### **2.2.1 Project/Site Supplemental Information**

The Erosion Prevention and Sediment Control (EPSC) Plans for the Initial, Interim, and Final Conditions (Drawings C-026 through C-037) have been revised to remove all proposed EPSC measures from the three (3) identified streams and to place additional controls adjacent to the streams. The revised EPSC plans accompany this supplemental information.

WASTEWATER TREATMENT PLANT EXPANSION  
BLEDSOE COUNTY CORRECTIONAL COMPLEX  
PIKEVILLE, BLEDSOE COUNTY, TENNESSEE SBC PROJECT 142/013-01-2013-06

| DRAWING NO.<br>C-026.1          |

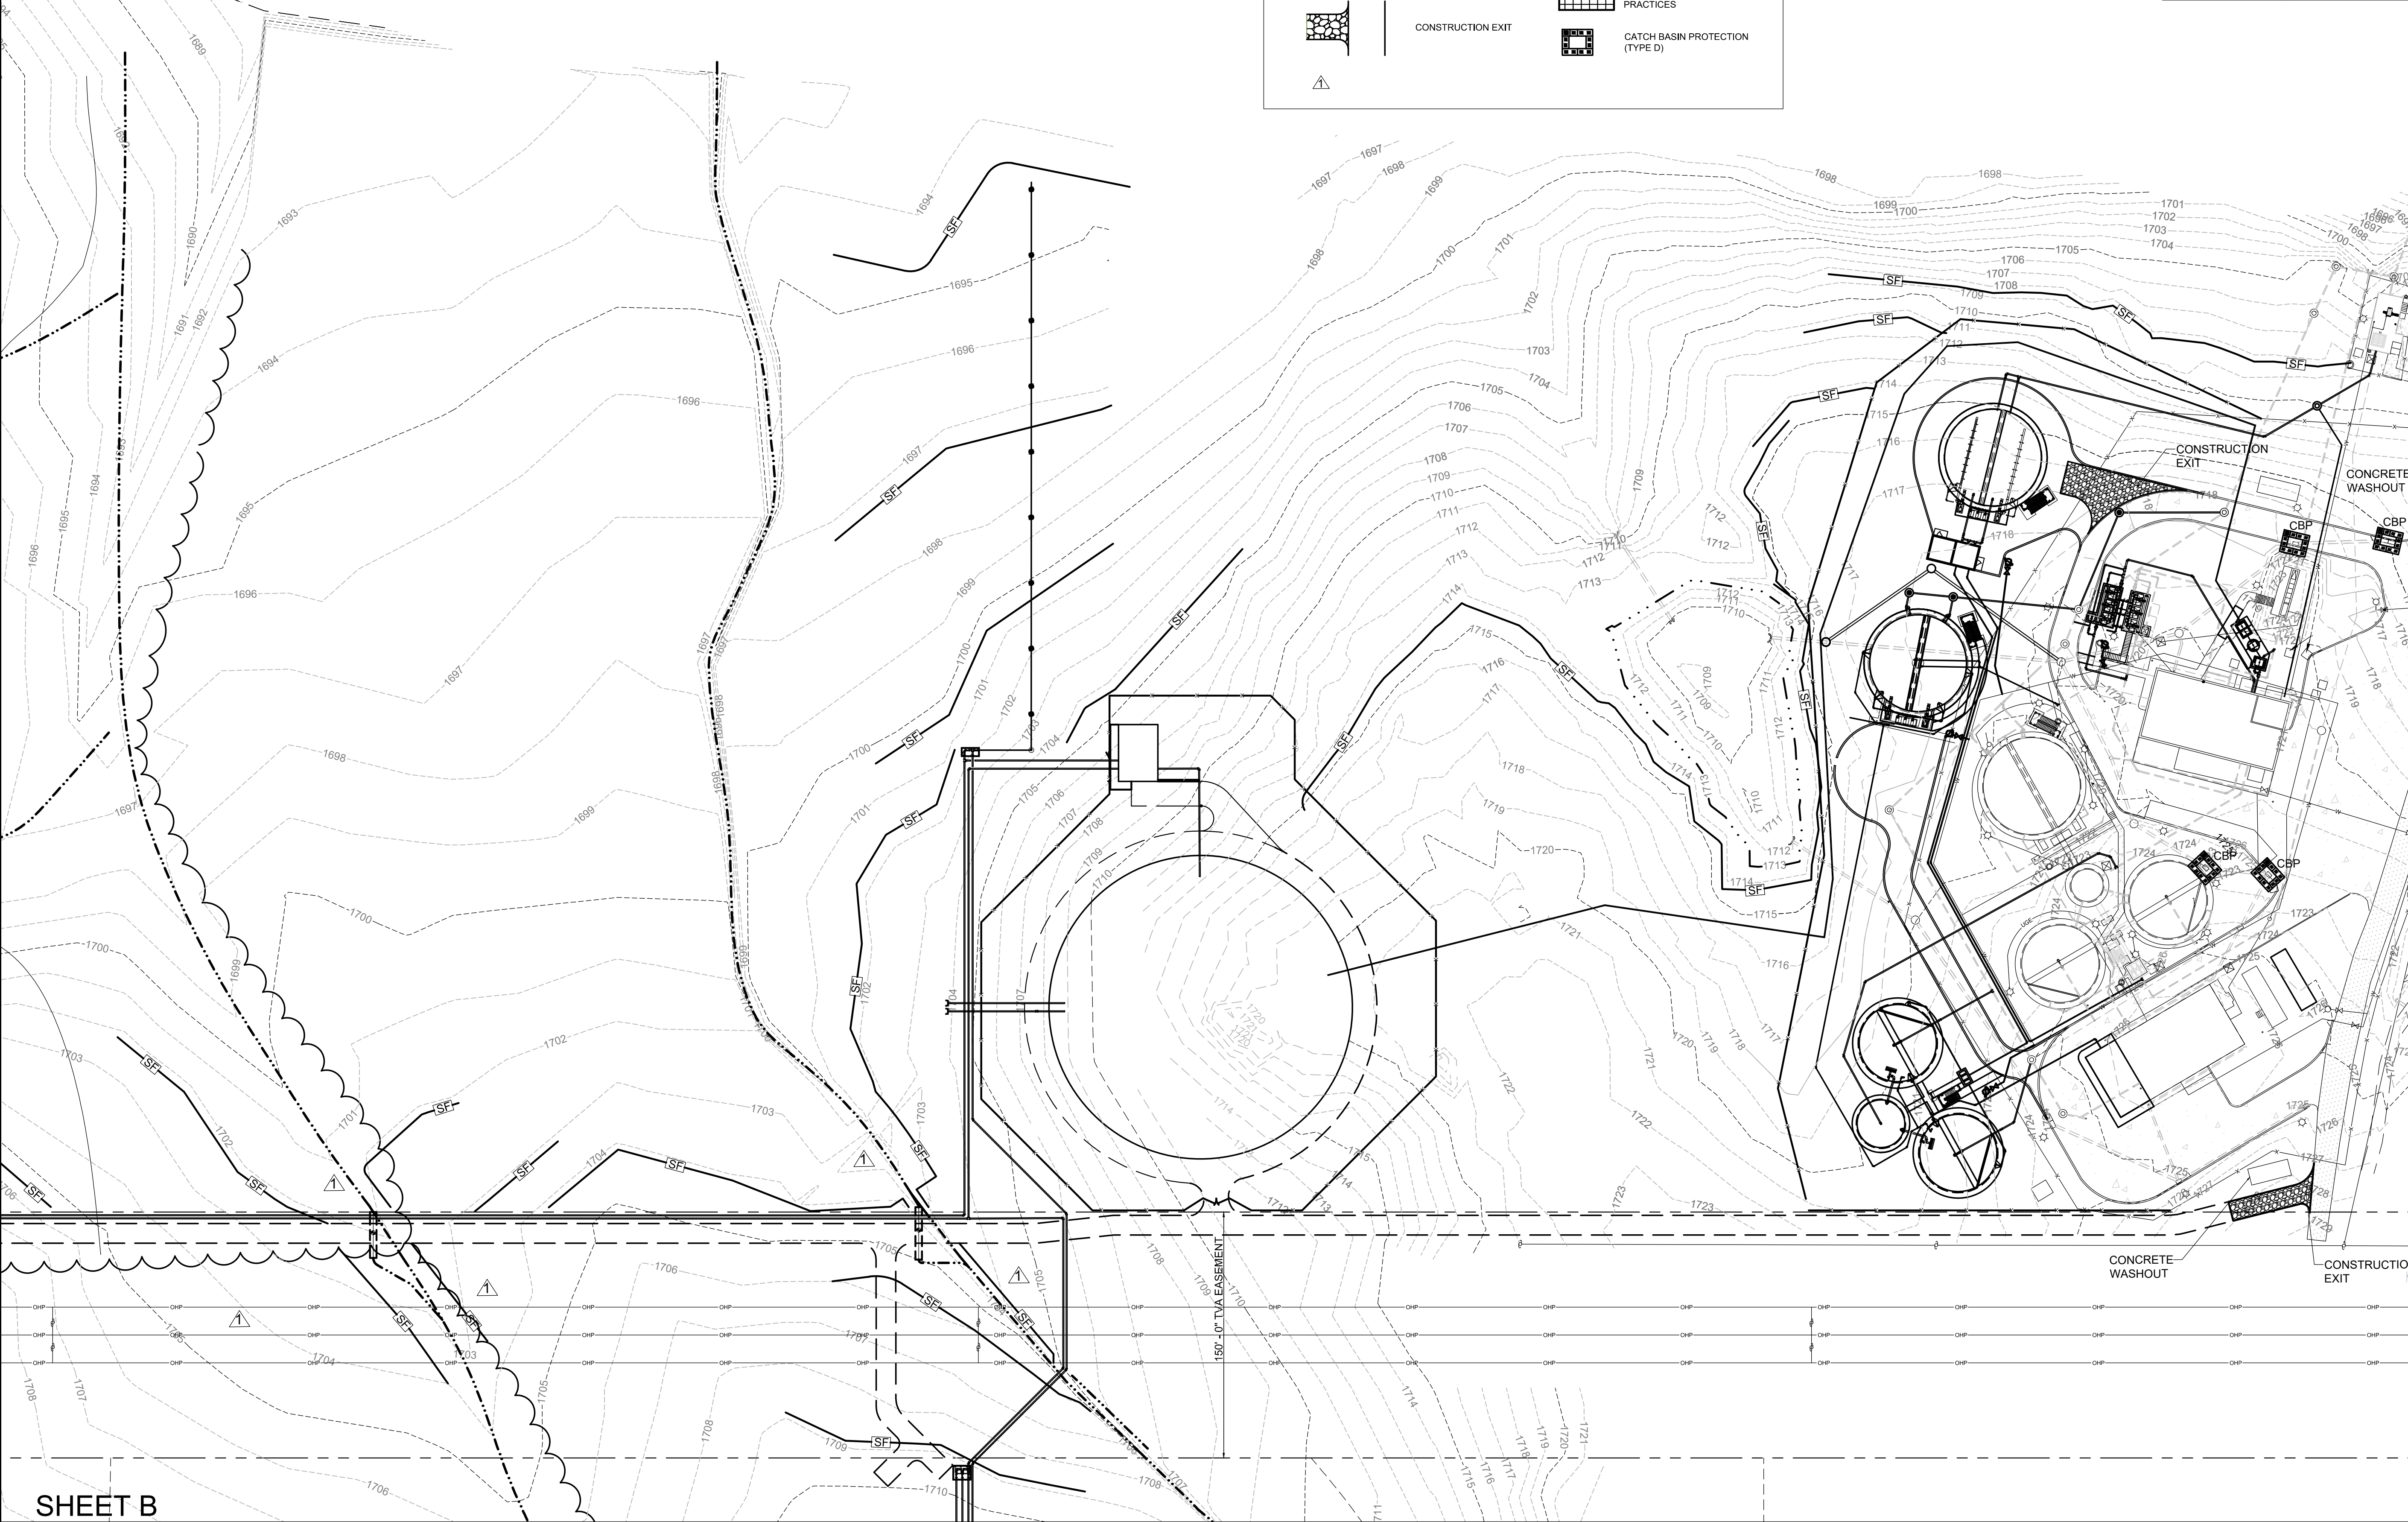
| REVISIONS |  | NO.     | DESCRIPTIONS | DATE | BY | APPD |
|-----------|--|---------|--------------|------|----|------|
| 1         | REMOVED EPSC MEASURES FROM DESIGNATED STREAMS, ADDED EPSC MEASURES ADJACENT. | 7/25/19 | NH           | NH   |    |      |
| 2         | REVISED LEGEND.  |         |              |      |    |      |

JOB NO.  
 N16003  
 ISSUE DATE  
 November 30, 2018  
 SCALE  
 1" = 50' - 0"  
 DRAWING NO.  
 C-027.1

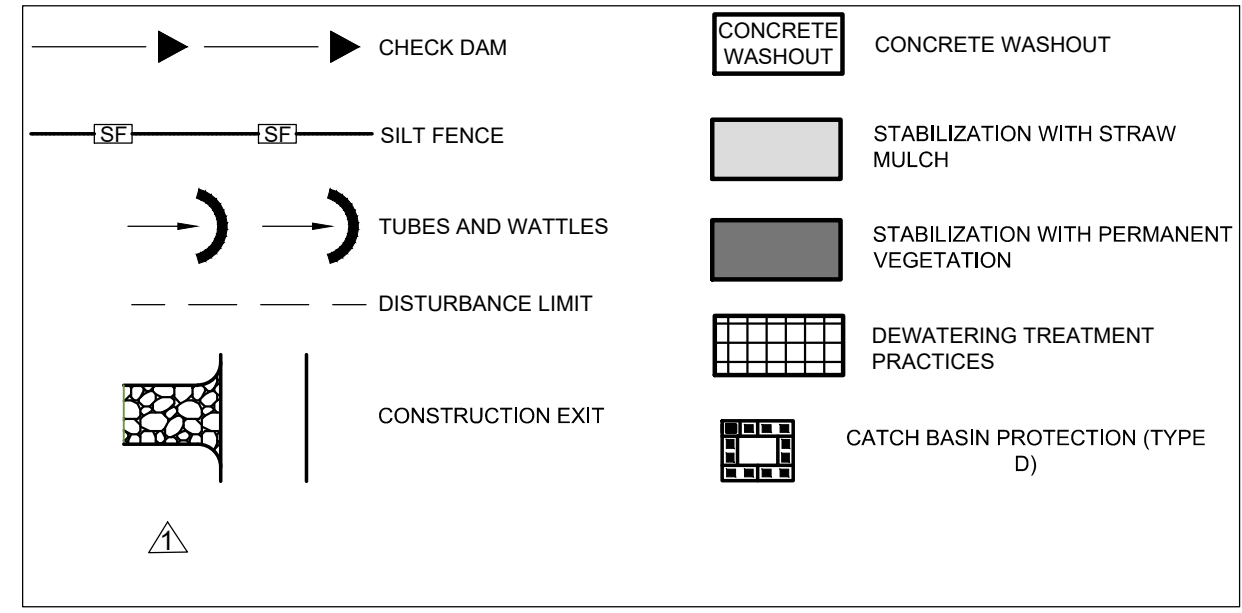
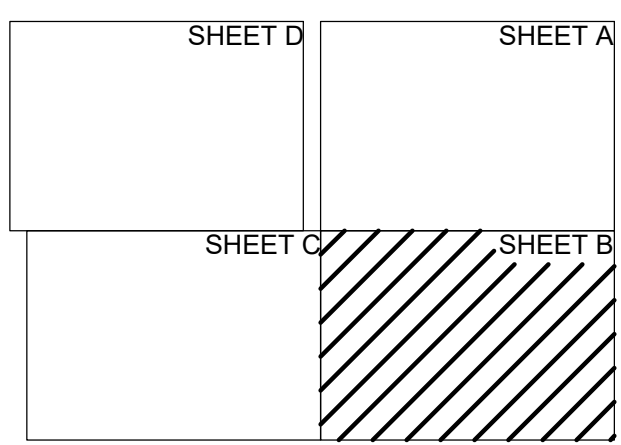
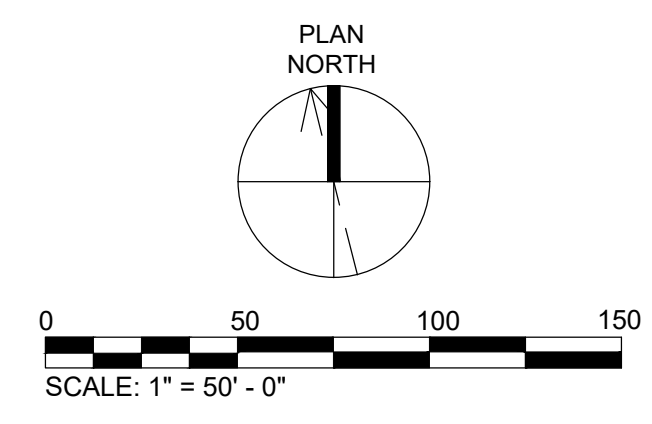
| DESIGN |     | REVISIONS  |         |
|--------|-----|--|---------|
|        | 1   | REMOVED EPSC MEASURES FROM DESIGNATED STREAMS, ADDED EPSC MEASURES ADJACENT. | 7/25/19 |
|        |     | REVISED LEGEND   |         |

DRAWING NO.  
C-028.1

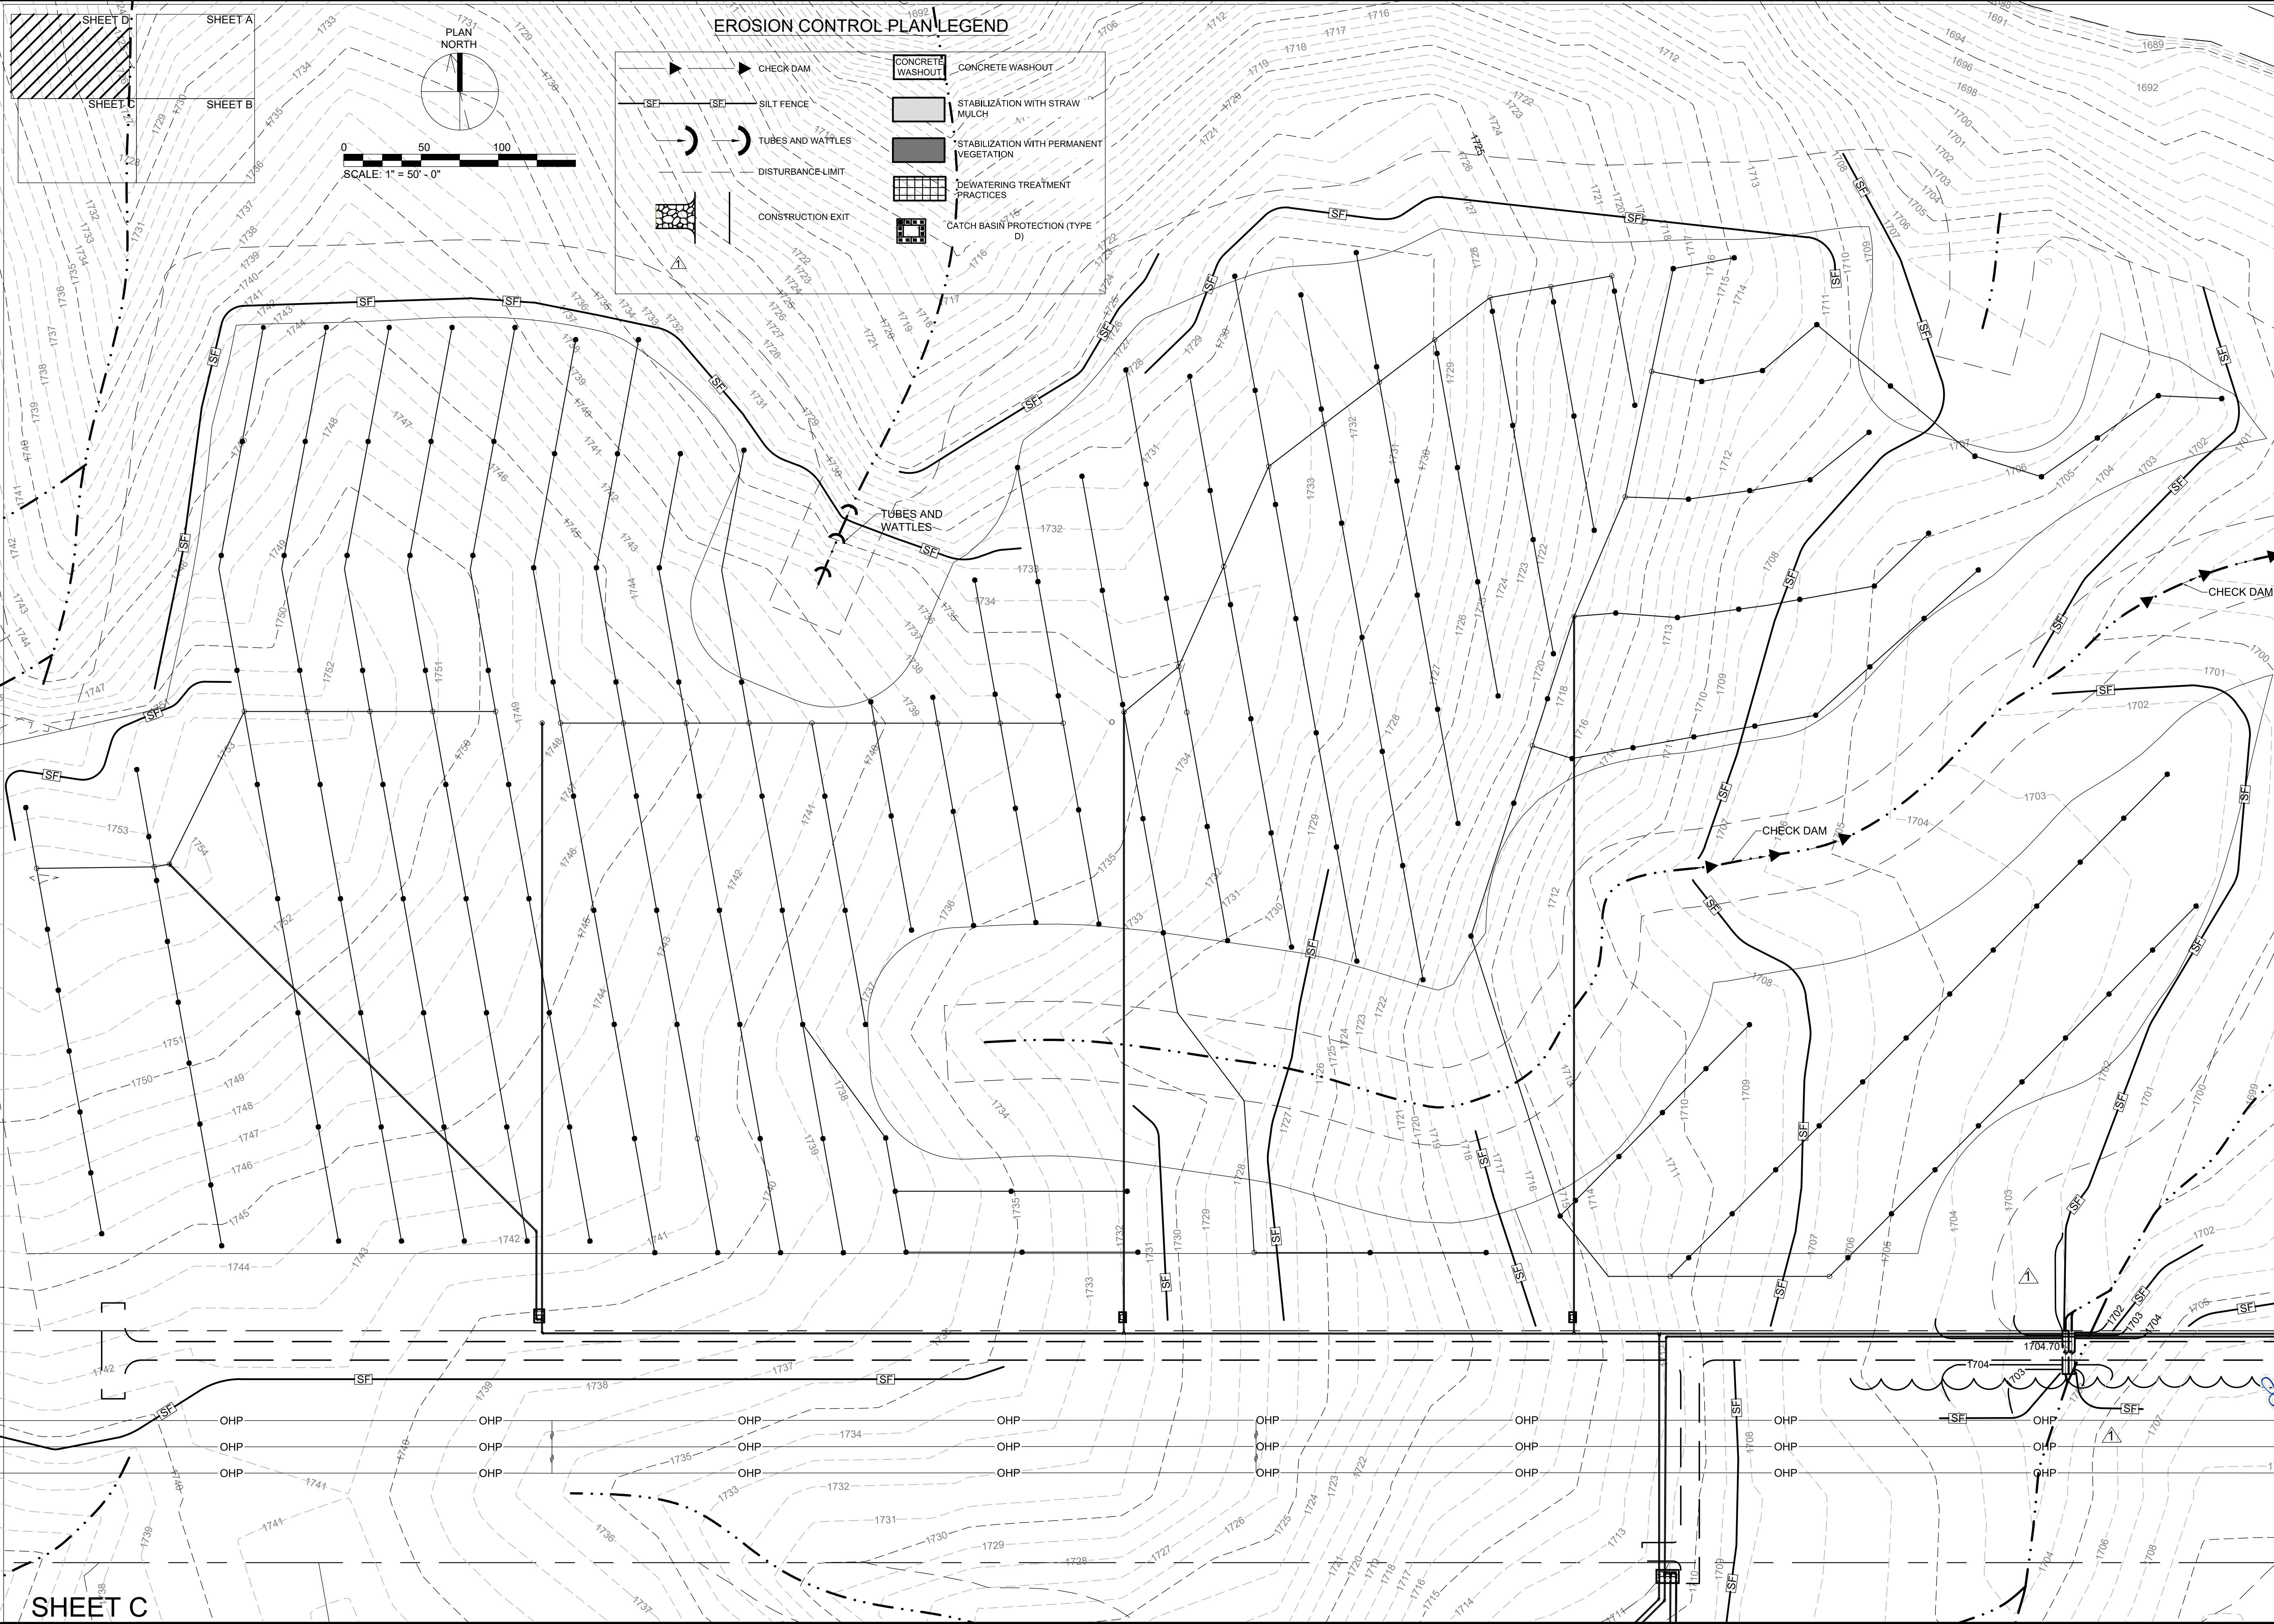
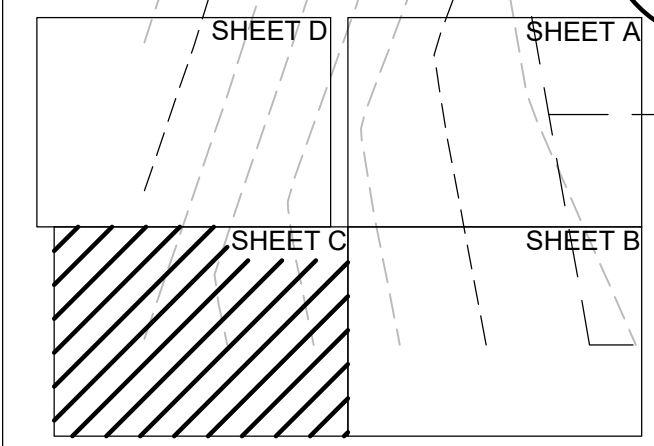
| REVISIONS |  | NO. | DESCRIPTIONS | DATE    | BY | APPD |
|-----------|--|-----|--------------|---------|----|------|
| Δ         | REMOVED EPSC MEASURES FROM DESIGNATED STREAMS, ADDED EPSC MEASURES ADJACENT. |     |              | 7/25/19 | NH | NH   |
|           | REVISED LEGEND   |     |              |         |    |      |

| DRAWING NO.<br>C-029.1          |

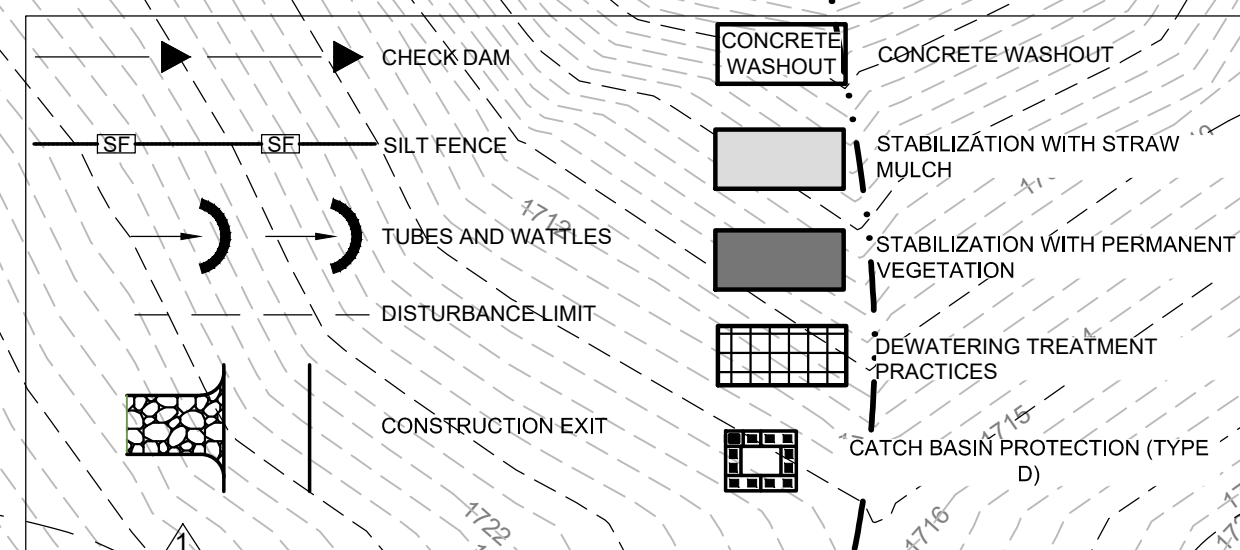
| NH     | NH  | REMOVED EPC MEASURES FROM DESIGNATED STREAMS, ADDED EPC MEASURES ADJACENT. | 7/25/19 NH NH |
| NH     | NH  | REVISED LEGEND.  |               |
